Re: Bayshore Pines RPD
DCI2022-00048

Below is our response to the letter of review dated Oct. 19, 2022. We are addressing each comment below for clarification.

BAYSHORE PINES RPD
BIG LLC
MASTER CONCEPT PLAN

Diagram of Deviation 2

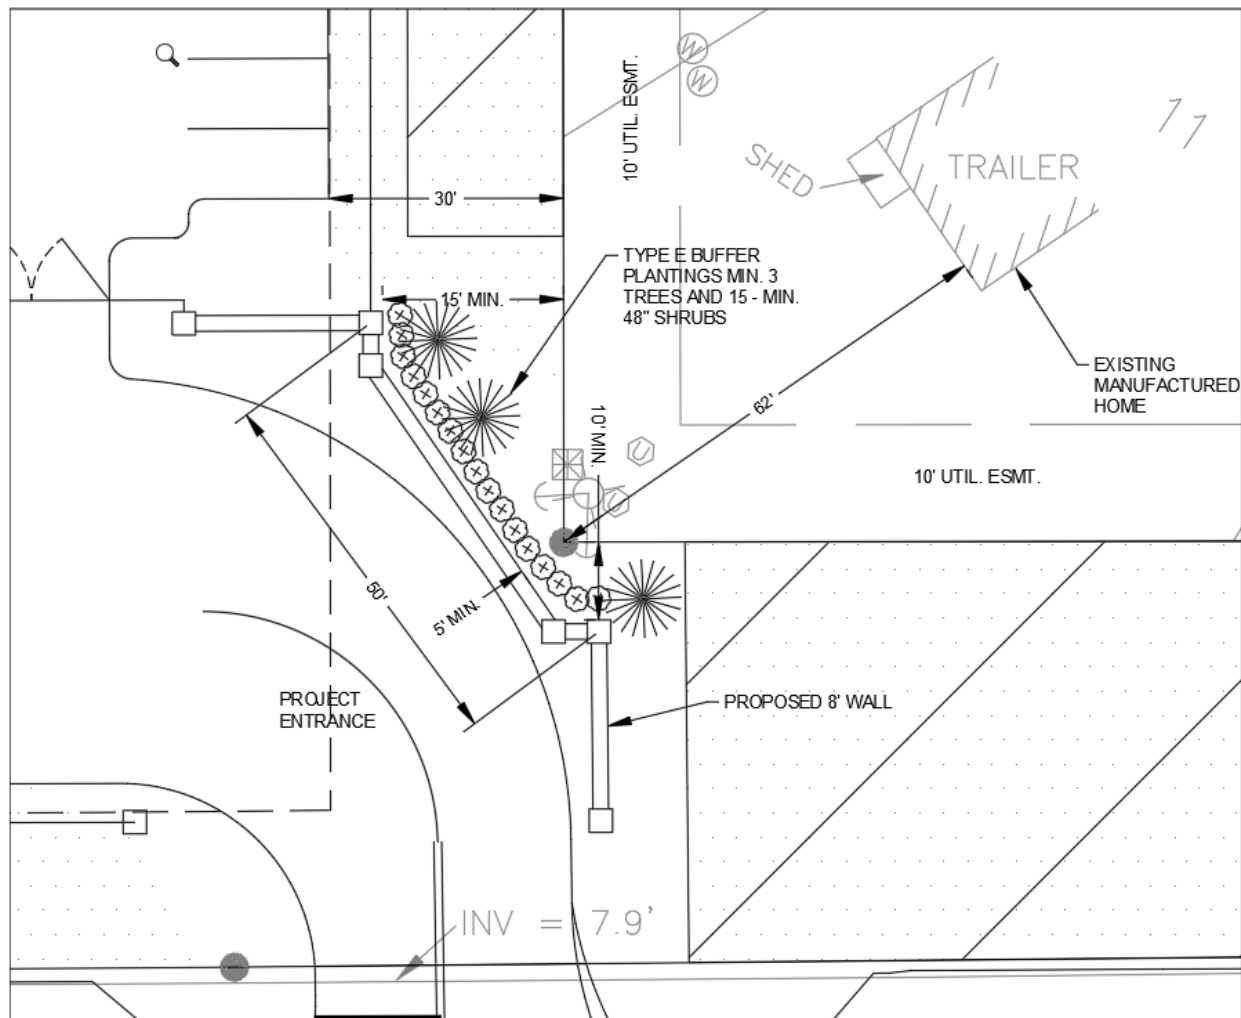
The MCP depicts a six-feet-in-height decorative wall along the southeastern corner. Deviation #2 is being requested to allow an eight-feet-in-height wall to be installed two feet from the property line at the corner. LDC Section 10-416(d)(6) requires the eight foot wall to be setback 25 feet. The wall is not decorative and is a requirement per code. The wall must be eight-feet-in-height. Revise the MCP to revise note to meet the LDC.

Revise Deviation #2 to indicate if the required landscape plants will be provided and depict on the detail drawing where the landscape plants will be proposed so that they do not conflict with offsite power lines and survivability.

LDC Section 10-421(a)2 requires a planting area to be no less than five feet. Deviation #2 indicates that in one area the width will be two feet. A deviation may need to be requested to allow less than five feet.

See the revised deviation request. We have been able to increase the wall setback from the corner of the property. The word decorative was not intended to mean the wall was not a code requirement. We are now refereeing to it as a buffer wall. The note on the MCP has been revised. The purpose of the deviation request is to address the unavoidable location of the wall due to the required FDOT driveway spacing.

Please see the revised deviation #2 request showing the buffer shrub and tree plantings along this wall. The required buffer trees and shrubs will be selected during the development order stage of the project and will be placed to avoid conflict with the adjacent off-site overhead power lines. There are no utility easements over this area.

See the revised deviation request. The provided buffer area will be no less than five feet at its minimum.

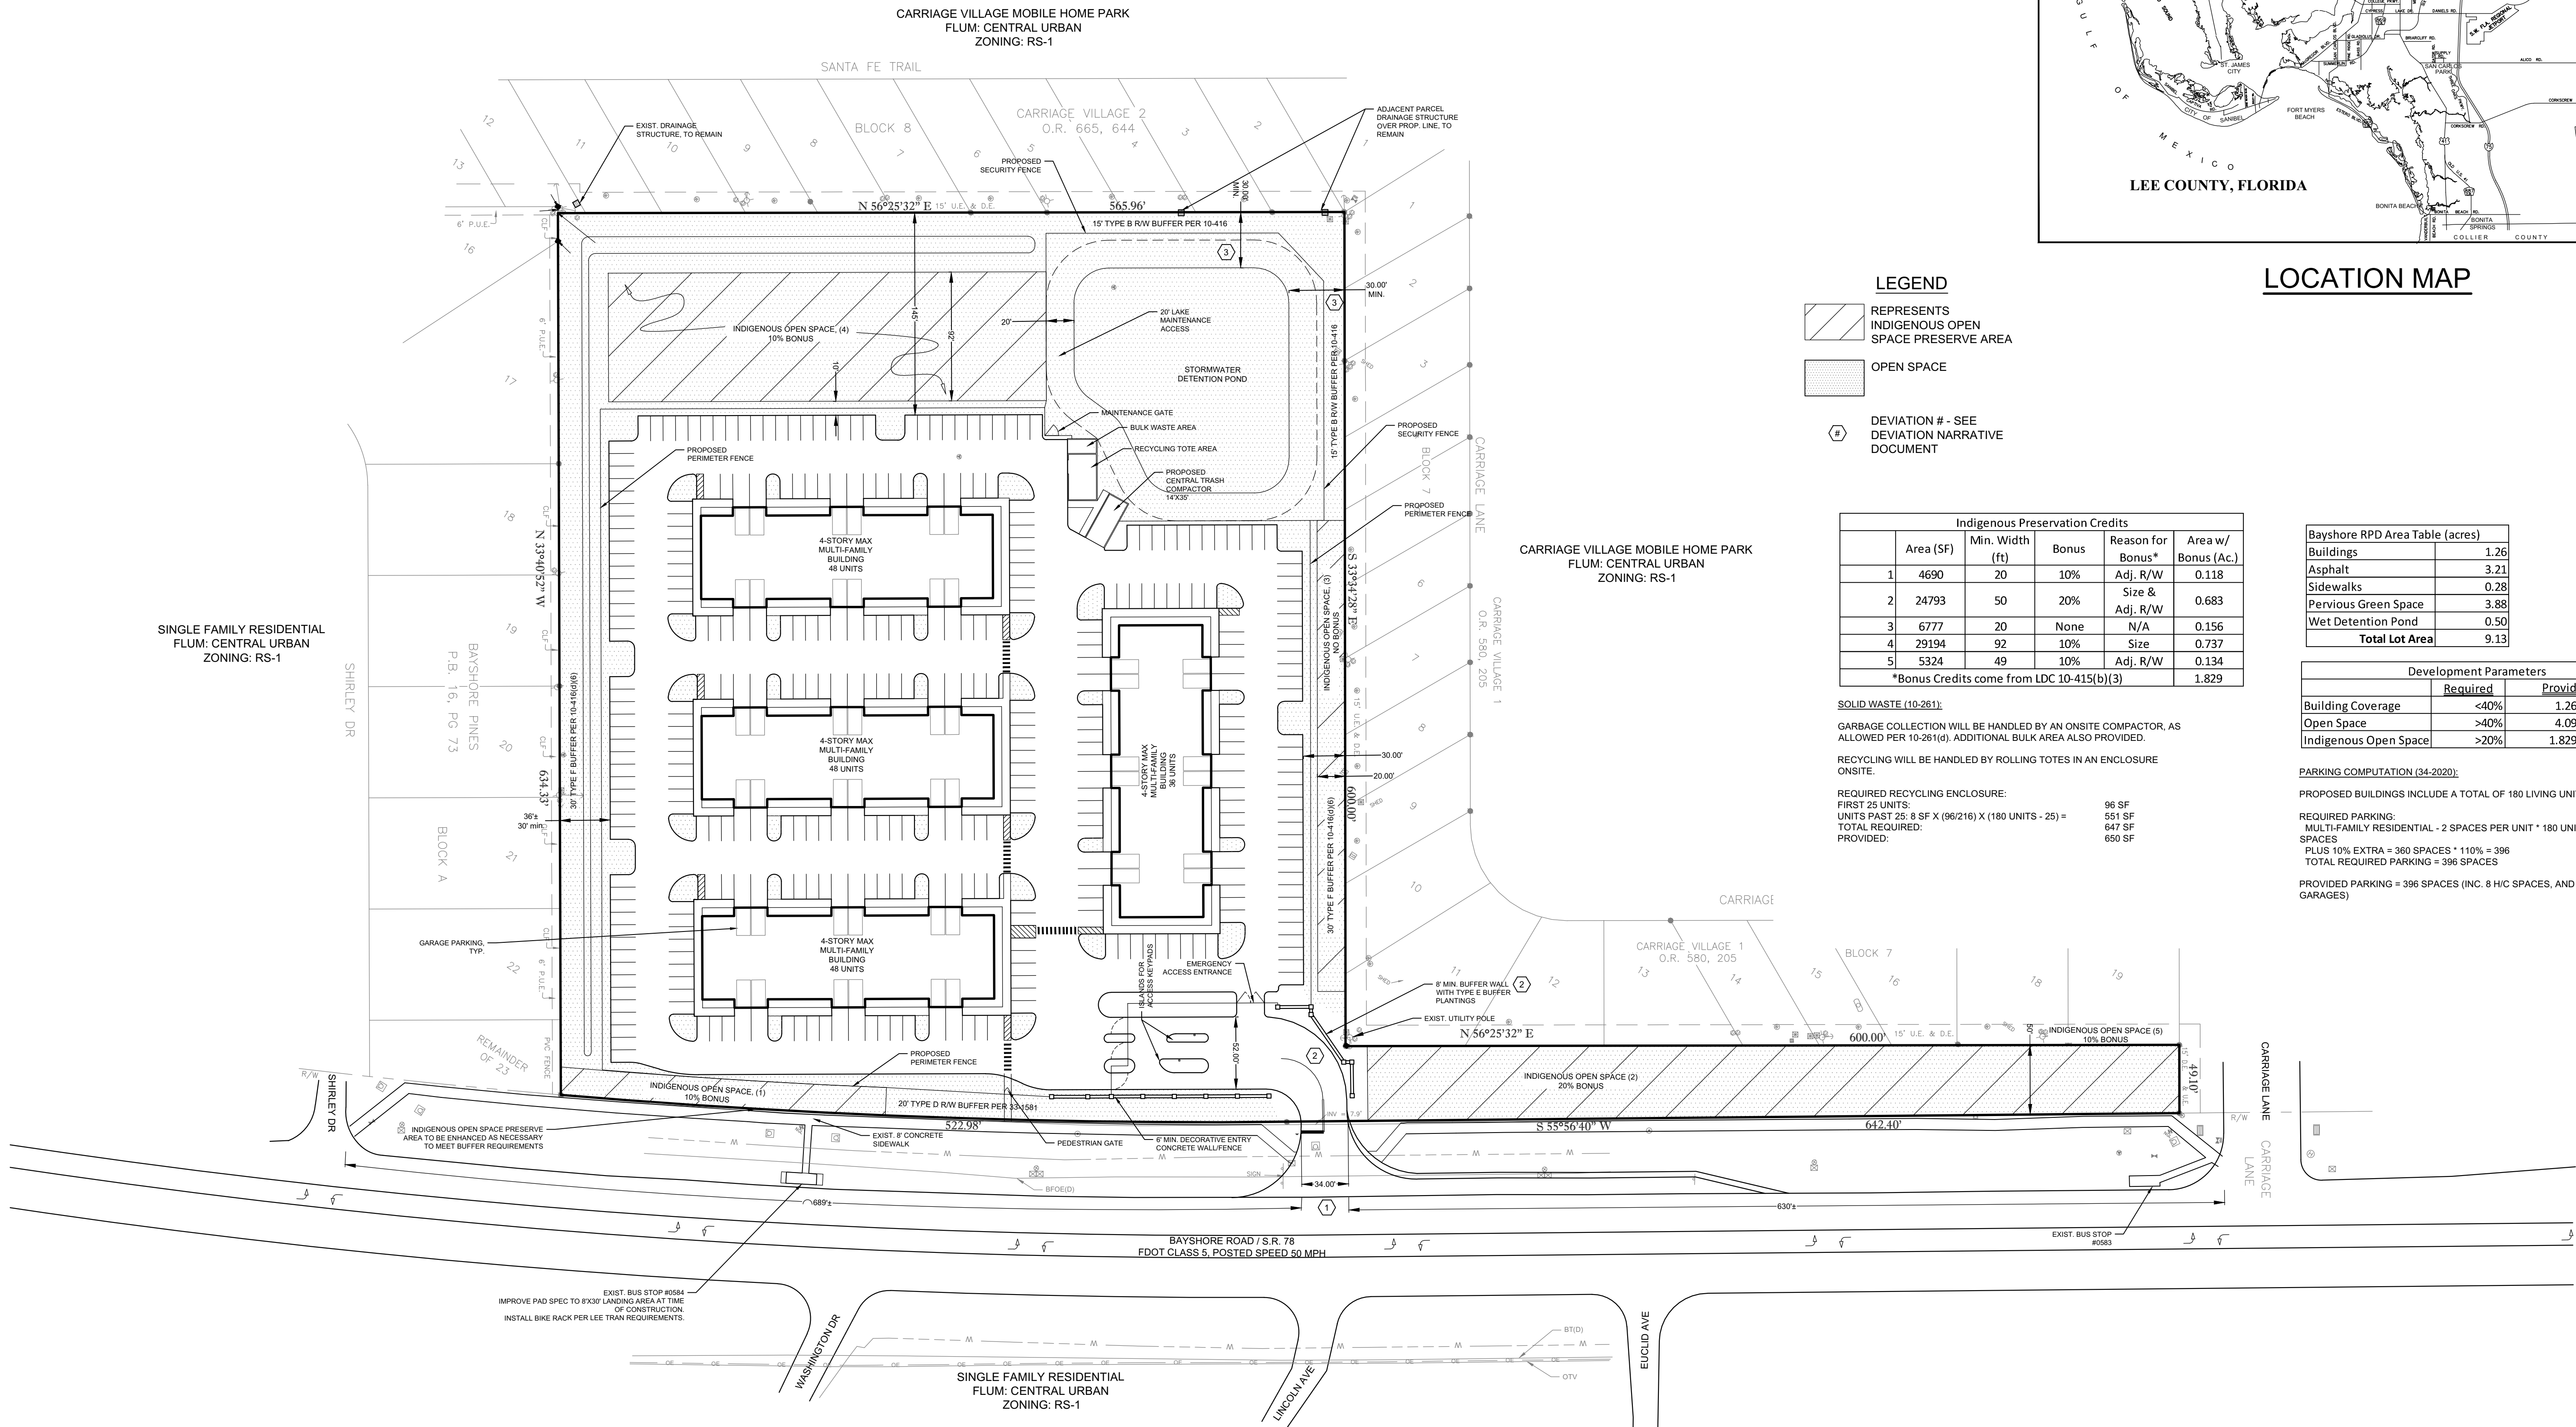
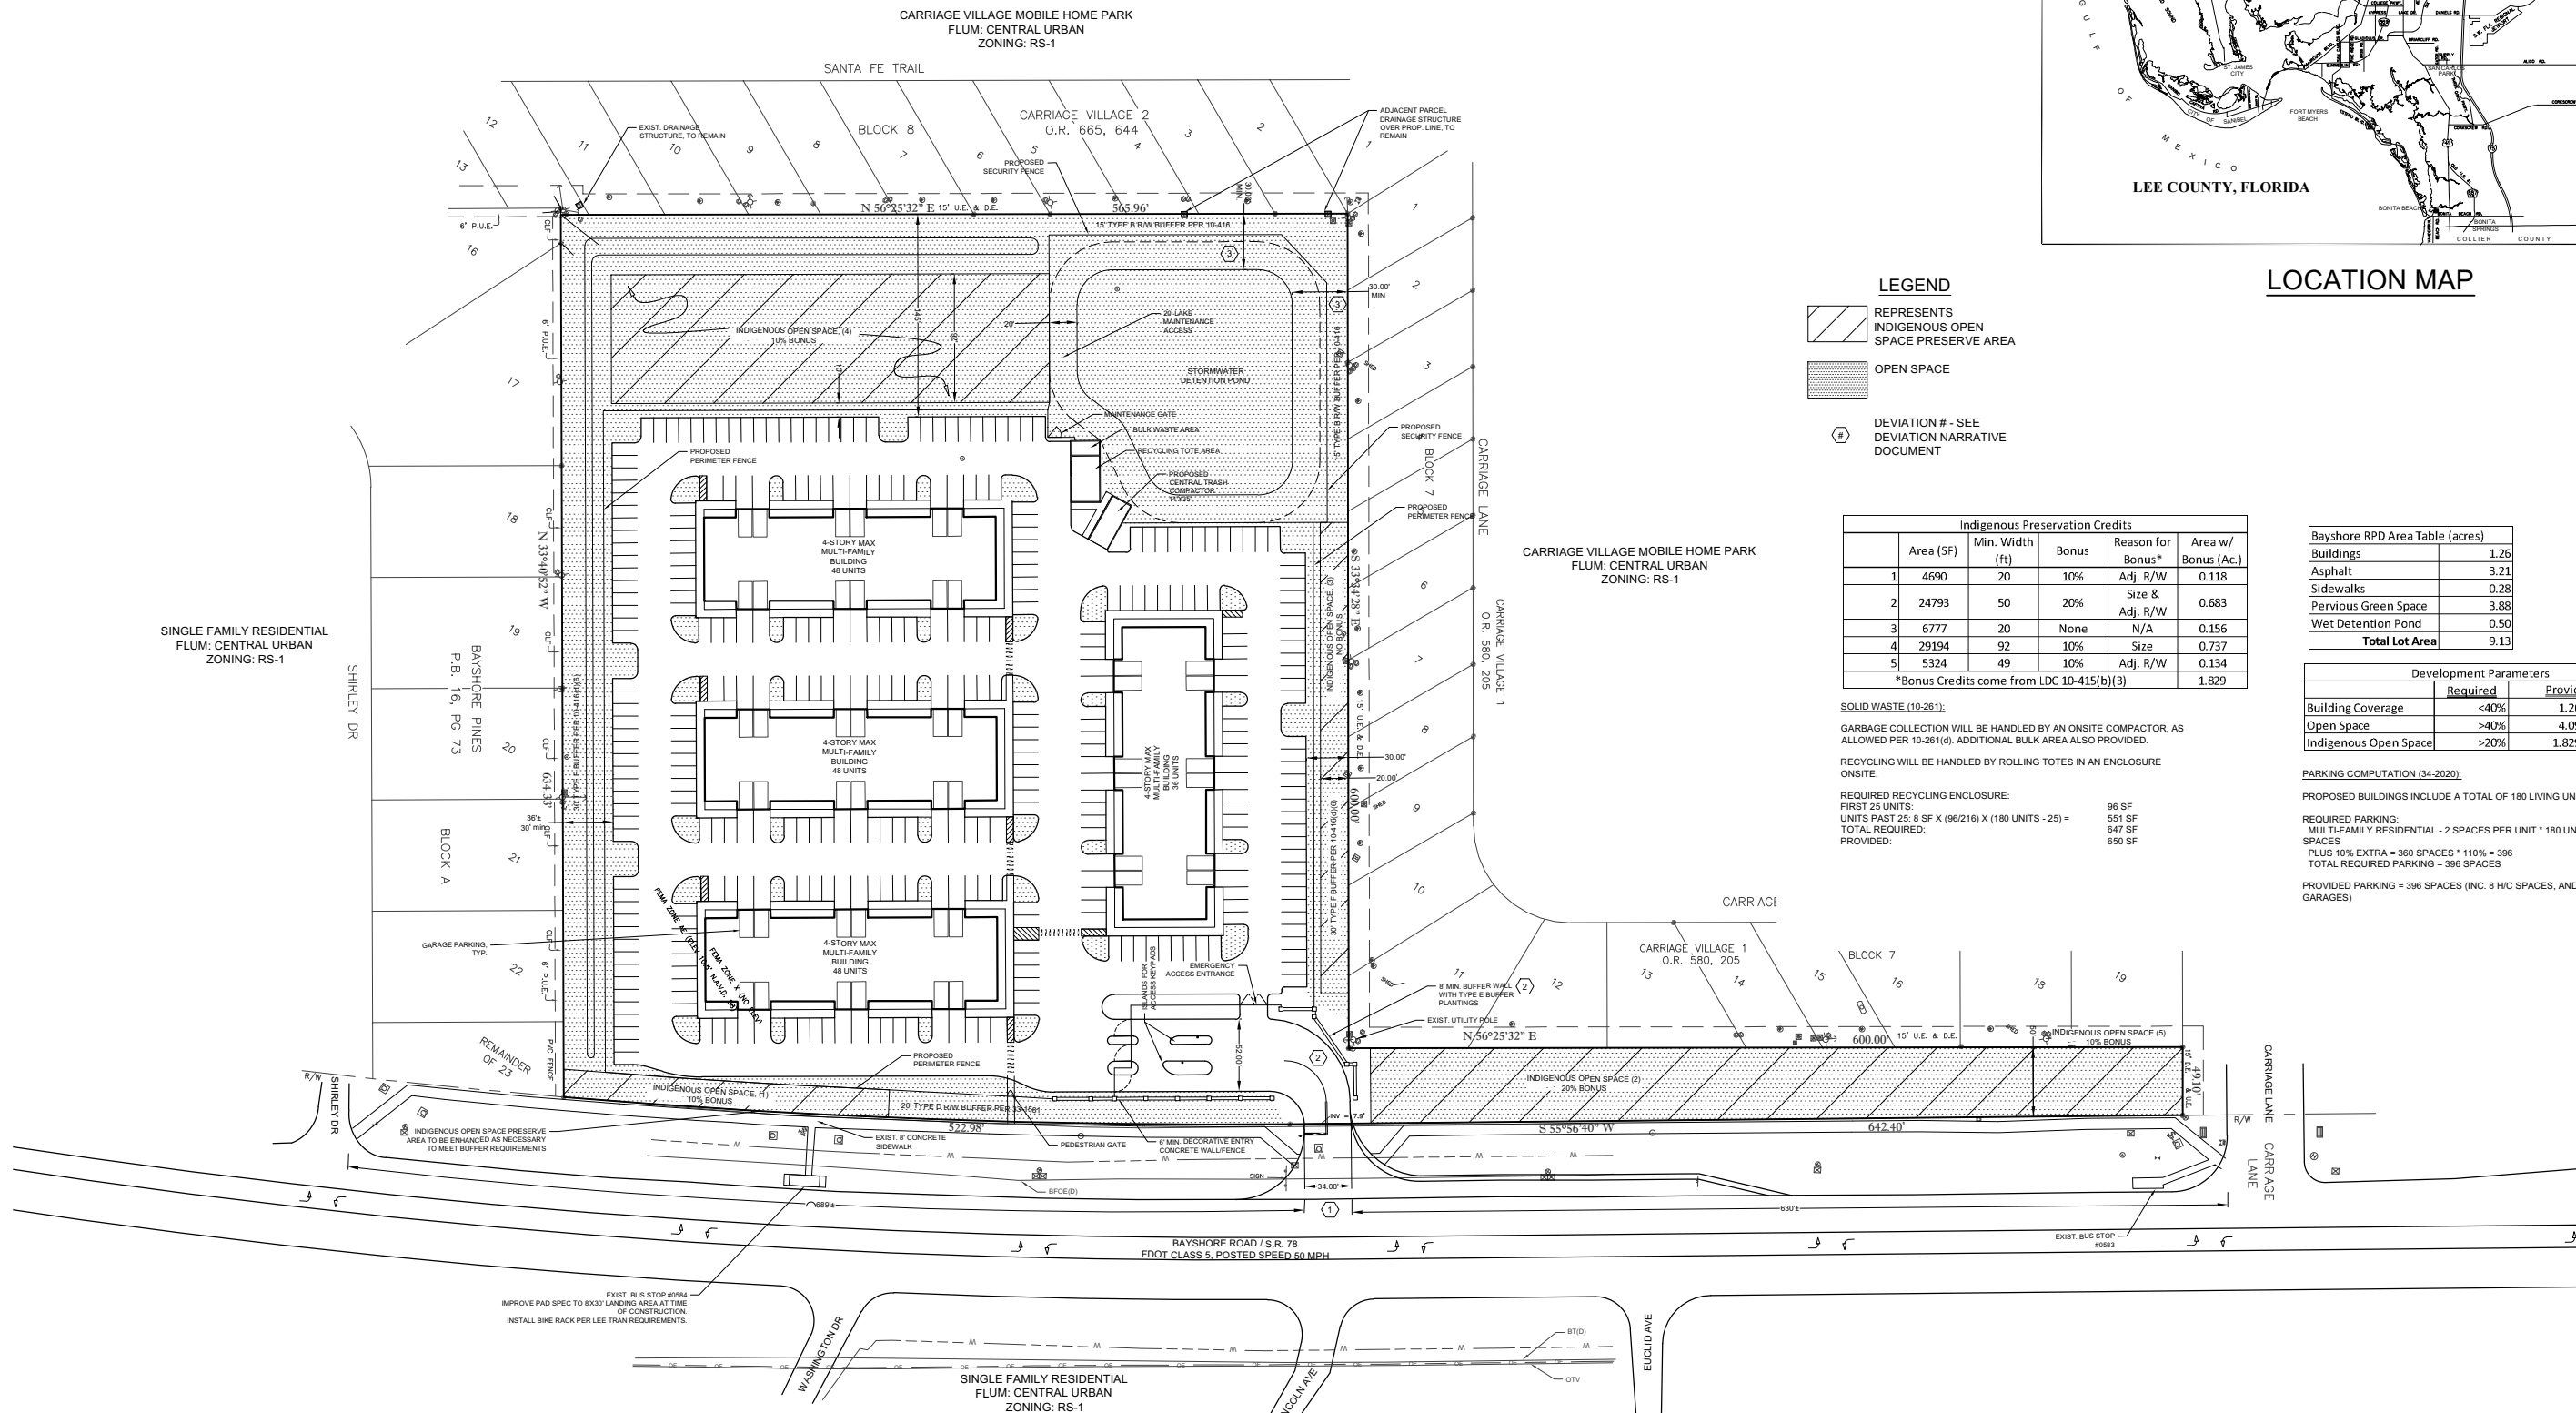
Please include dimensions of recycling dumpster and compactor area in accordance with Ordinance 11-27 and LDC 10-261.

5. LDC 34-373(a)(6)(c) - The plan must indicate the general location, configuration, and approximate dimensions of the lots or parcels (including subdivided parcels and outparcels). Please provide lot dimension on the MCP.

6. LDC34-373(a)(6)(i) Proposed access and facilities for public transit in accordance with sections 34-411(e) and 10-442. The MCP shows a bus stop. Are any improvements to the bus stop facilities required in accordance with the sections above? These improvements must be shown on the MCP.

The MCP depicts the open space percentage as 40% but does not provide the indigenous credit allocation per LDC Section 10-415(c). The MCP notes that "bonus" indigenous will be allocated but does not provided the information in the open space calculation. Revise MCP to list the percentages and indigenous open space acreage. Please note that indigenous credits is only allowed for indigenous areas (75% or less exotic) and uplands.

The MCP depicts a Type-B buffer being provided along the north property line as well as using the preserve for buffering with supplemental plants proposed as needed per note. Please explain why a Type-B buffer is being provided if the indigenous preserve may serve as screening to comply with code. If it meets the buffer, remove the Type-B buffer depiction and use the entire area as preserve.

It is the intent of this project to provide domestic solid waste service with a compactor and roll off container. We are hesitant to provide exact dimensions at this stage as the final dimensions will be perfected during the development order process. We are withdrawing the deviation request relative to the solid waste area. It was not clear to us that 10-262(d) (compactors) is allowed as a substitute to garbage collection area requirements of 10-262(a). The recycling area will be provided in addition to the compactor area as required in 10-261(a). We have added a solid waste computation on the master concept plan.

We have added the overall parcel dimensions to the site plan. No other lots are proposed.

We are showing on the MCP the improvements to the existing Lee Tran bus stop typically required during the development order process. We are not aware of any additional improvement that would be required. The modifications will be included as part of the development order application as is typical with or without this RPD application.

We have revised our indigenous open space preservation areas to reflect the updated FLUCCS mapping. We have added a table to the MCP outlining each indigenous area, its size and allowed bonus per the code. Note, there is one area of indigenous preservation which we propose to enhance and restore along Bayshore Road. We have included a detailed planting plan for this area. We have added a separate open space plan sheet to help depict the indigenous preserve areas and the restoration plantings.

We have removed the Type B buffer note. The indigenous preserve area will serve as the required Type B buffer. The entire area between the parking area and the property line will be used as open space but does not all qualify as indigenous preserve due to what we believe is prior clearing activity.
